RS-02-030

March 19, 2002

Braidwood Station, Units 1 and 2  
Facility Operating License Nos. NPF-72 and NPF-77  
NRC Docket Nos. STN 50-456 and STN 50-457

Subject: Request for a License Amendment to Modify the Method of Controlling  
Unfavorable Exposure Time Related to an Anticipated Transient Without Scram  
Event for Byron and Braidwood Stations

**Figure 1**  
**Hot Full Power MTC for Hypothetical High Reactivity Core**

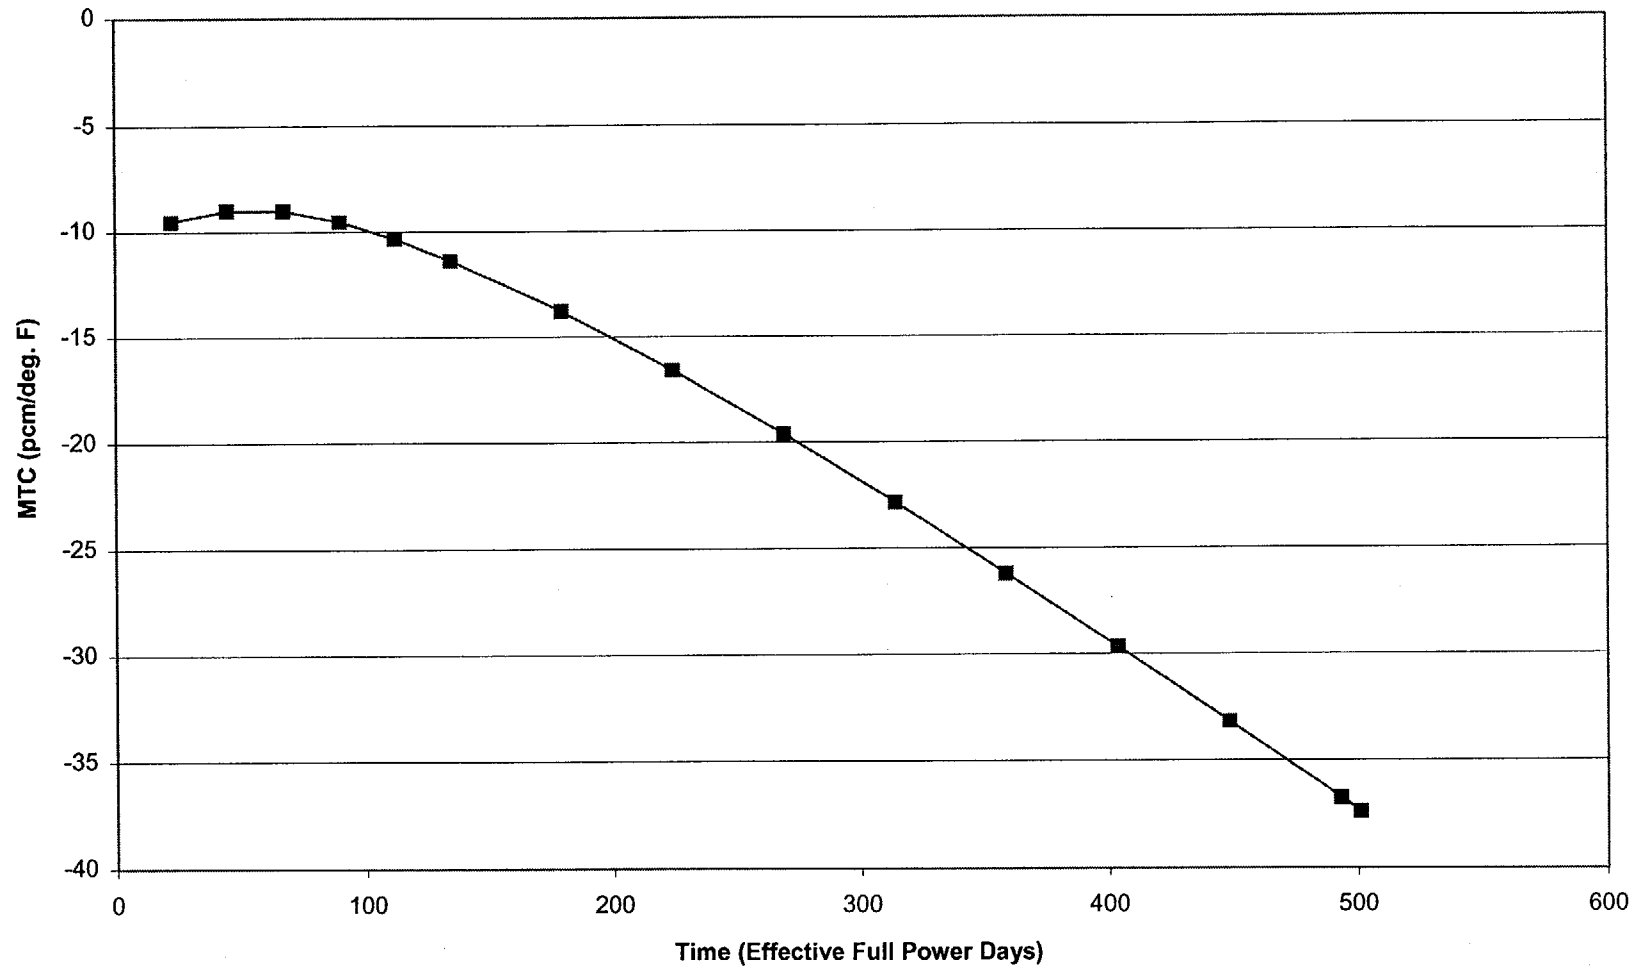
Cycle-specific design critical power trajectories and UET values, based on different combinations and availability of ATWS risk significant equipment, will be calculated using the methods described above. As an example, Table 1, "UET for a Hypothetical High Reactivity Core, One Minute of Control Rod Insertion (72 Steps)," shows six different combinations of AFW system and pressurizer PORV availability with rod motion available and the associated UET expressed in number of fuel cycle days and in percent of fuel cycle. Table 2, "UET for a Hypothetical High Reactivity Core, No Control Rod Insertion," shows six different combinations of AFW system and pressurizer PORV availability with no rod motion and the associated UET expressed in number of fuel cycle days and in percent of fuel cycle. This hypothetical high reactivity core would have a maximum HZP MTC of +3.78 pcm/°F at a burnup of 3000 Megawatt-day per Metric Tonne Uranium. The information from Tables 1 and 2 were then combined to develop a plant configuration logic matrix for equipment necessary to maintain zero UET as shown in Table 3, "Plant Configurations to Maintain No UET for a Hypothetical High Reactivity Core." Effective configuration management control will be exercised throughout the operating cycle, not solely for the "base case" UET period.

For informational purposes, Figure 1 shows the MTC profile as a function of burnup at HFP for this hypothetical high reactivity core.
